CCW IMPOUNDMENTS INSPECTION REPORT

ROXBORO STEAM ELECTRIC PLANT
PERSON COUNTY,
NORTH CAROLINA

PROJECT NO. 09-4157
DECEMBER, 2009

TRANSMITTAL
ASSESSMENT OF DAM SAFETY OF
COAL COMBUSTION SURFACE IMPOUNDMENTS
FINAL INSPECTION REPORT
SITE 29 (ROXBORO)

PHOTO 12: TOE OF FGD SETTLING POND (LOOKING S)

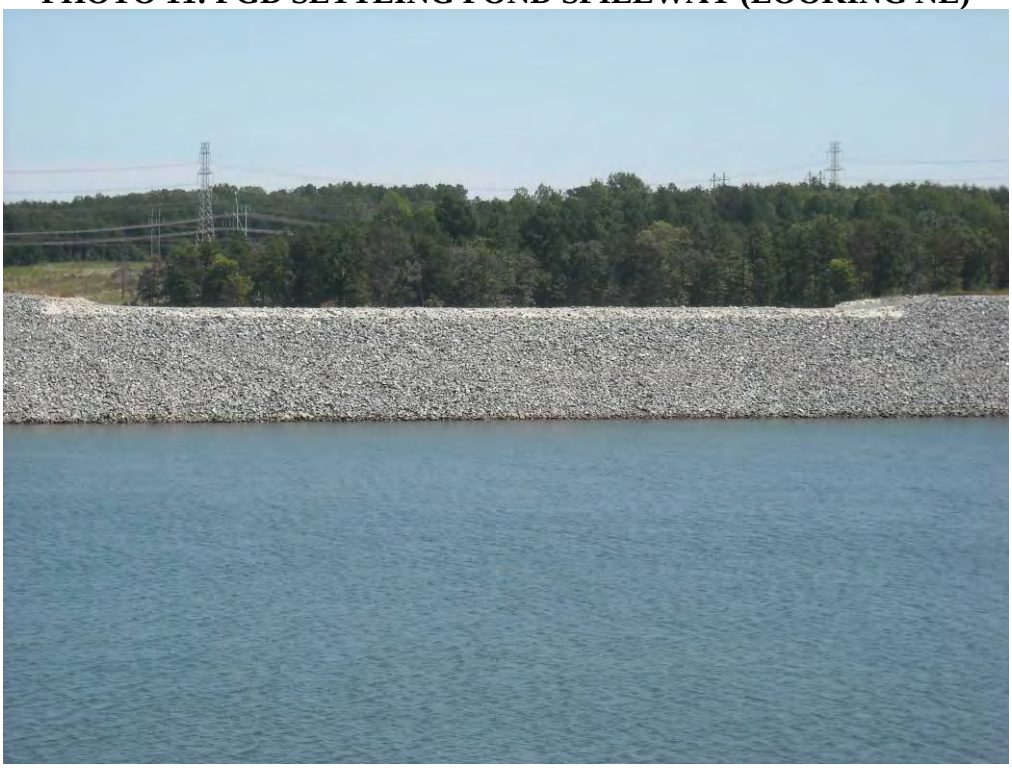
Continue to monitor the seepage at the toe of the Settling Pond Dike until the pond is taken out of service for repairs.
Schedule: According to existing plans.
